# Data Request Response #1

# Corby Battery Energy Storage System Project (24-OPT-05)

April 2025

This Data Request Response #1 to North Bay Interconnect, LLC and Corby Energy Storage, LLC's (Applicant)<sup>1</sup> Opt-in Application (Application) for the Corby Battery Energy Storage System Project (Project) (24-OPT-05), responds to comments that California Energy Commission (CEC) Staff have made as a result of their data adequacy review of the Application, as documented in their Determination of Incomplete Application and Request for Information letter dated December 9, 2024. The intention of this supplement is to provide all additional information necessary for Staff to find that the Application contains adequate data to begin an Opt-in Renewables site certification proceeding under California Code of Regulations, Title 20, Section 1877, and Public Resources Code, Section 25545, for the technical areas included in the submittal.

BCR-P004-01

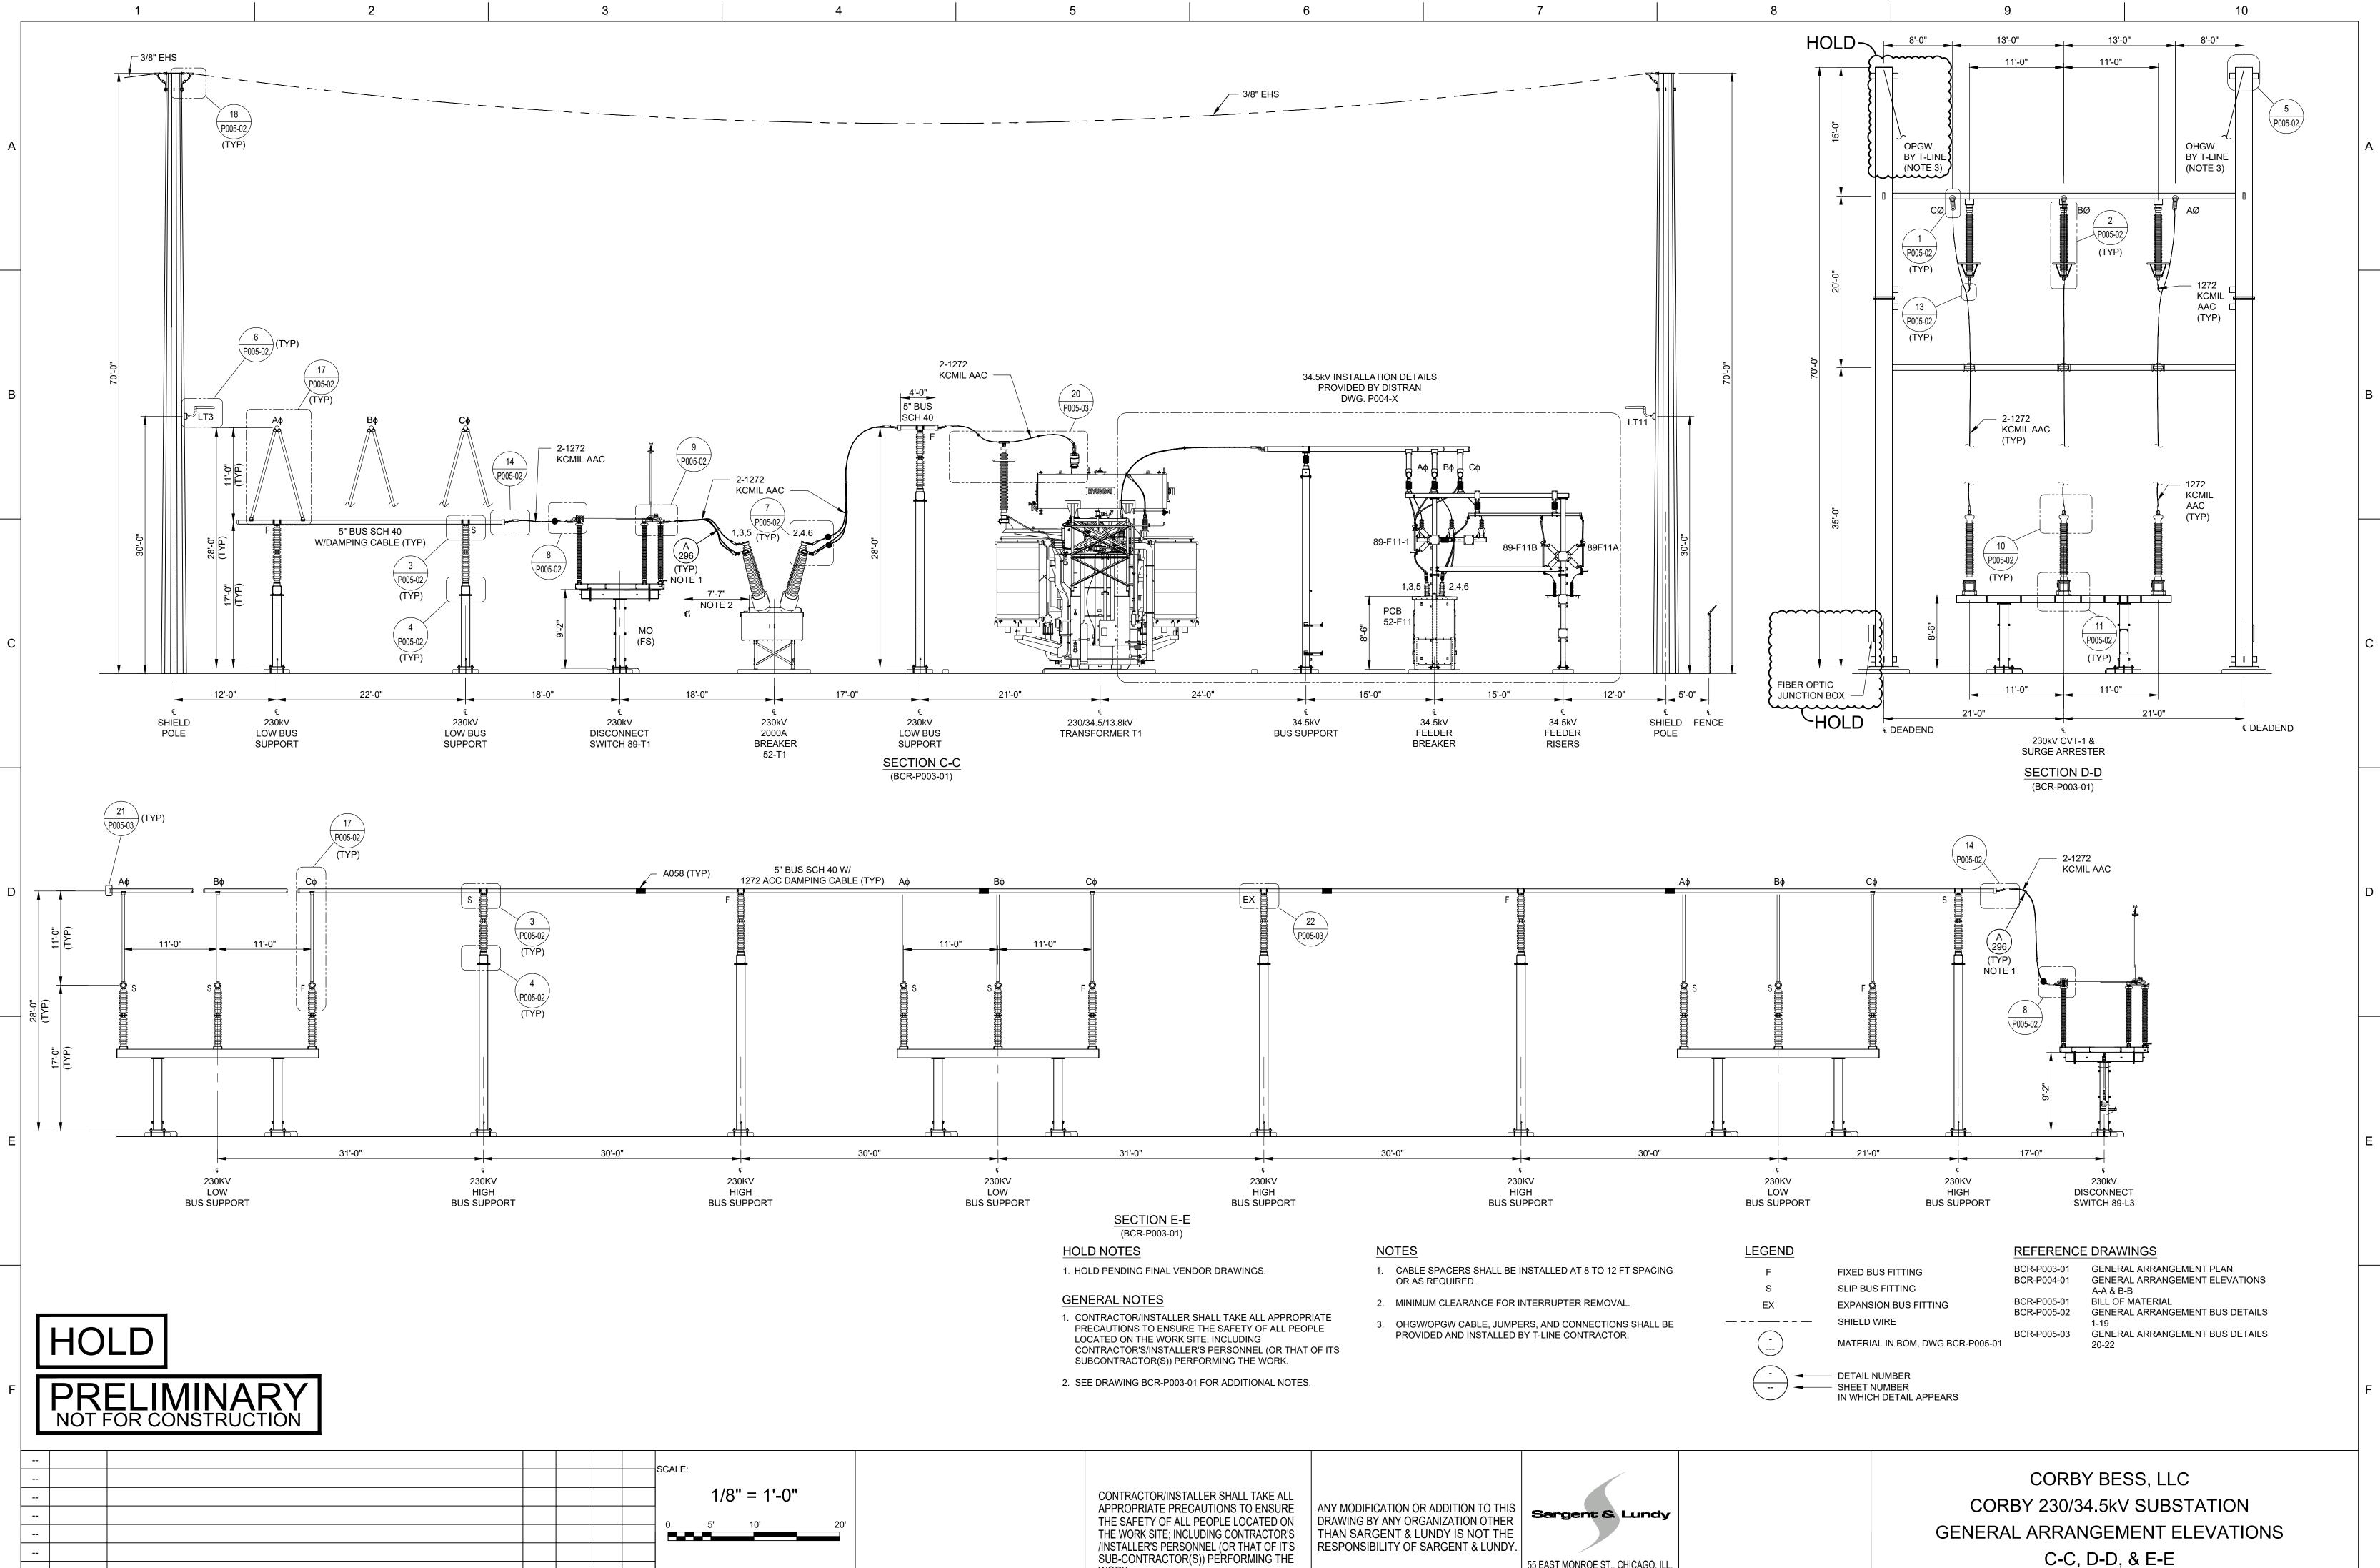
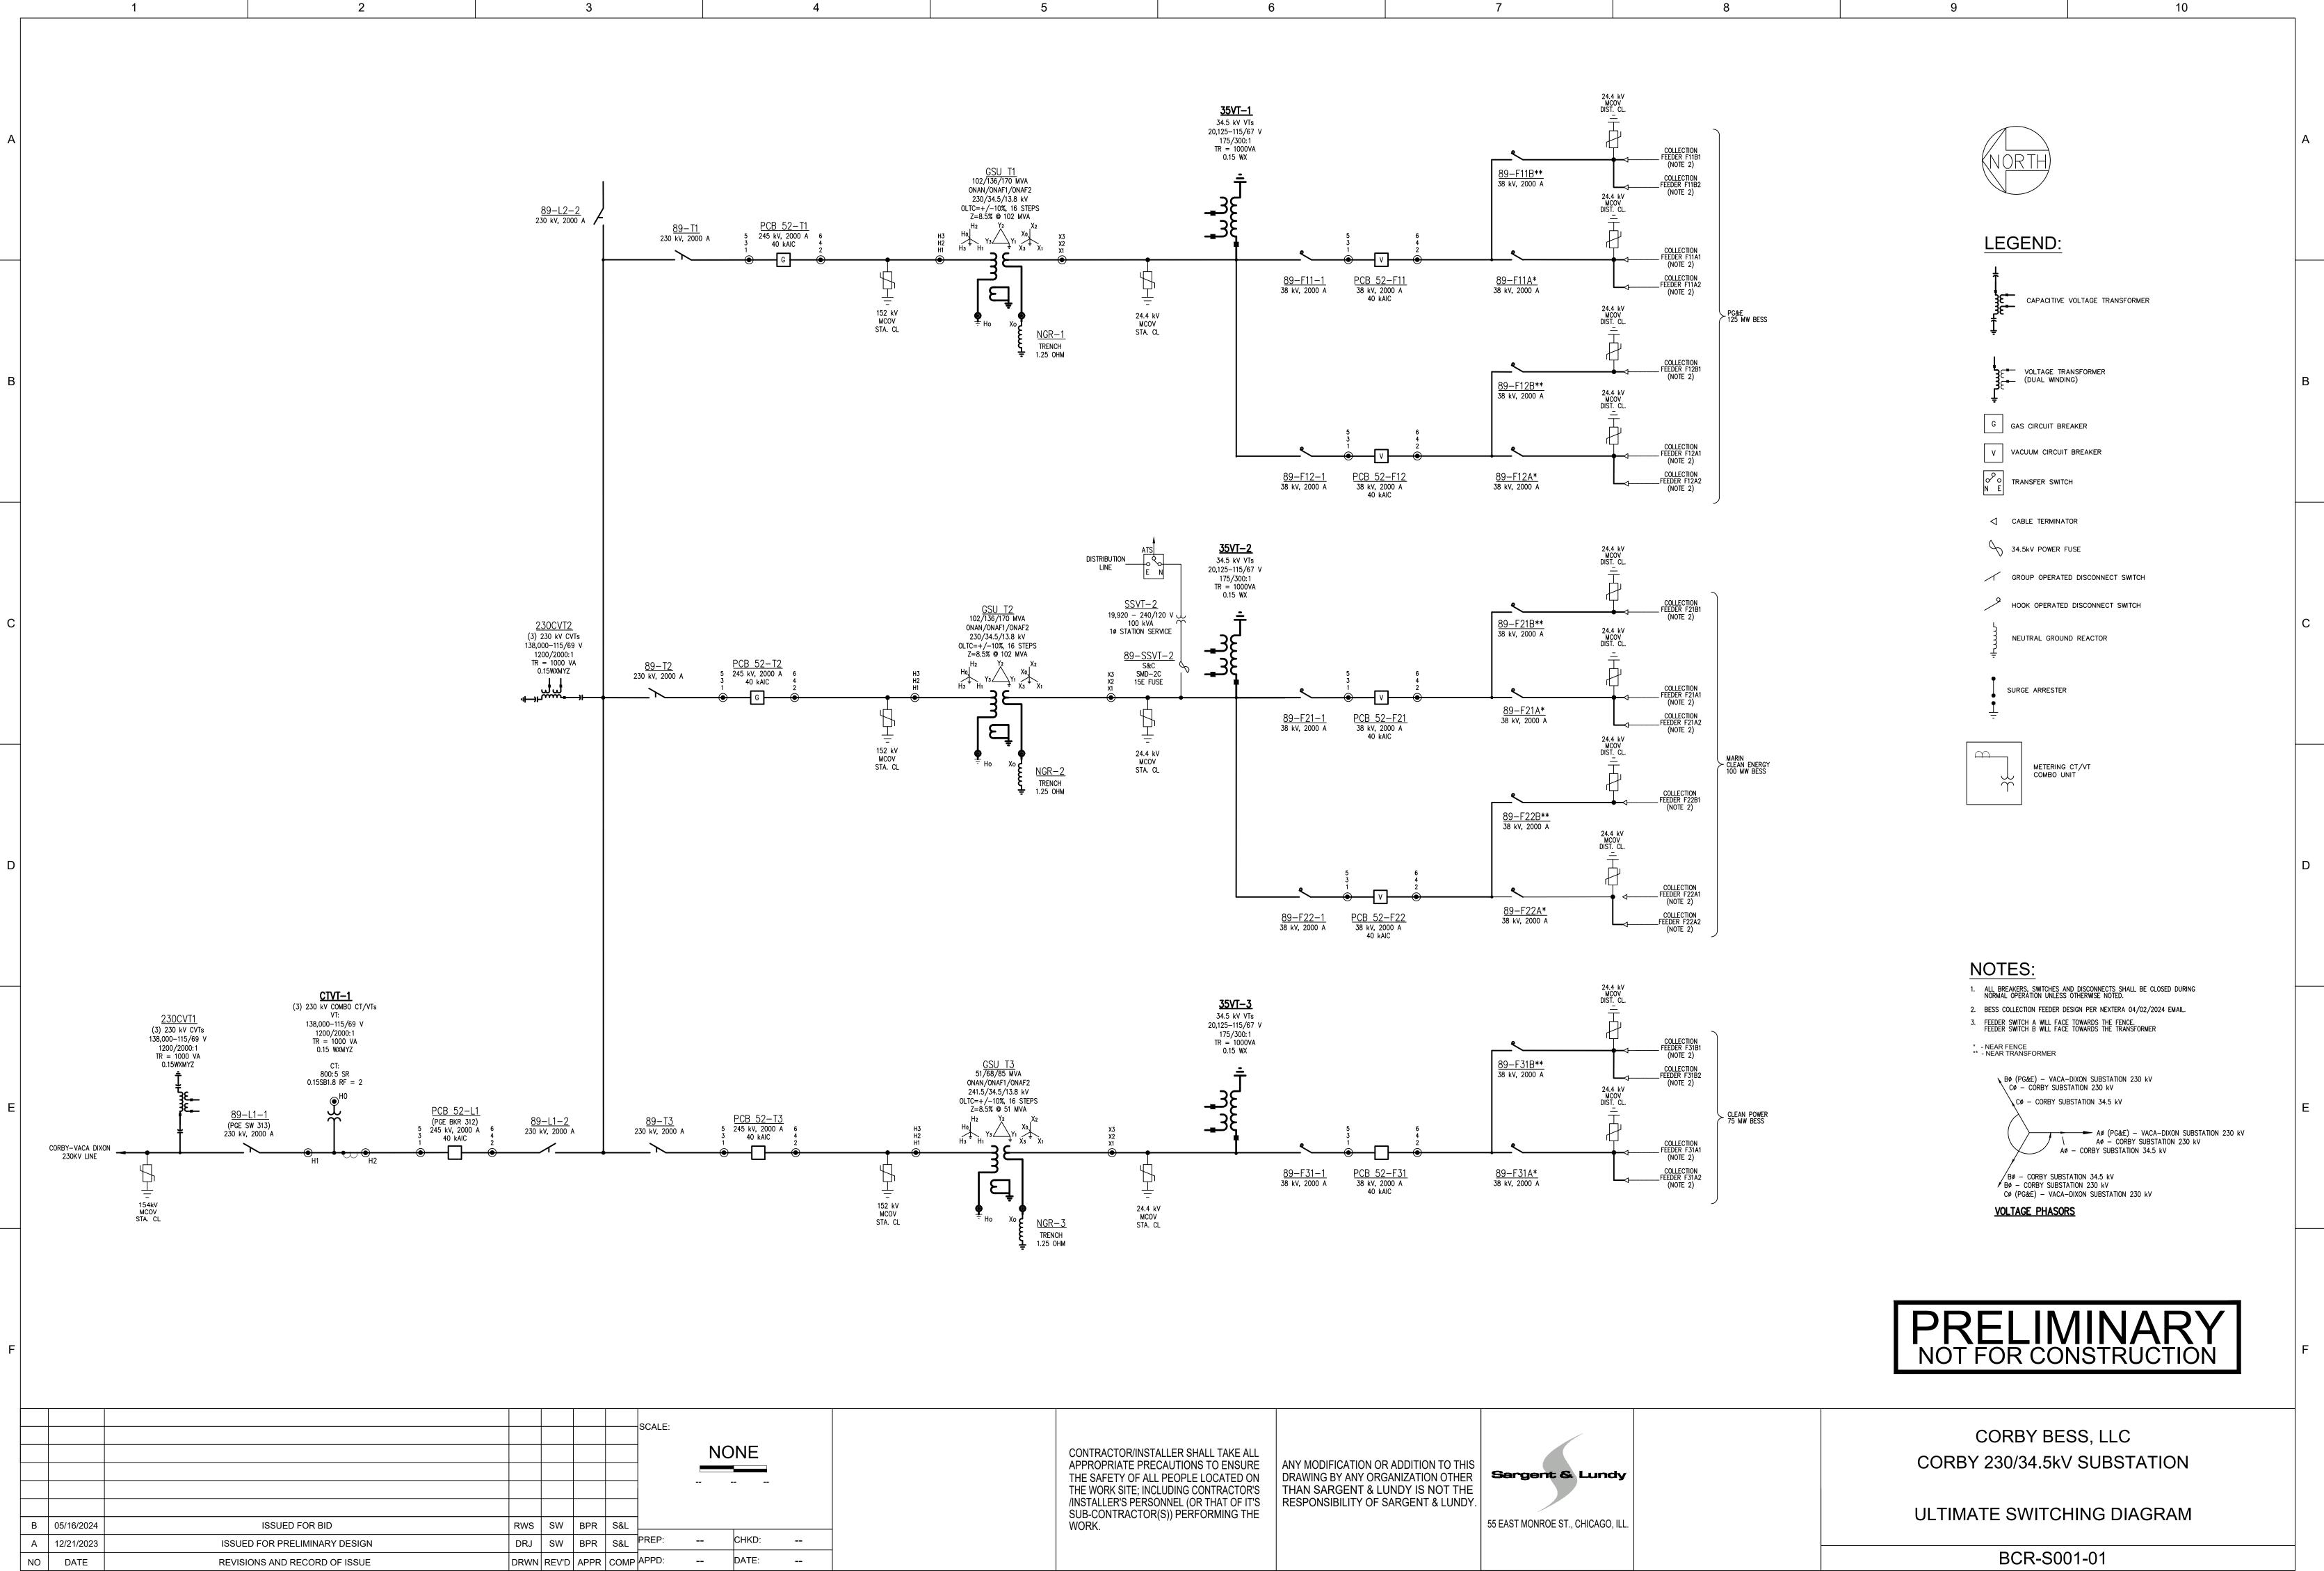
**DR TSD-1.** Please resubmit Figures 3-5a, 3-5b, 3-5c and 3-6. These figures submitted are not legible. Show all equipment ratings including the bay arrangement of the circuit breaker, disconnection switches, buses, transformers, and other equipment that would be required for the project interconnection to the proposed switchyard.

**Response:** The process of converting the original engineering drawings into Figures 3-5a, 3-5b, 3-5c, and 3-6 resulted in reduced resolution; therefore, the original engineering drawings are provided in Appendix 8-A to ensure improved resolution.
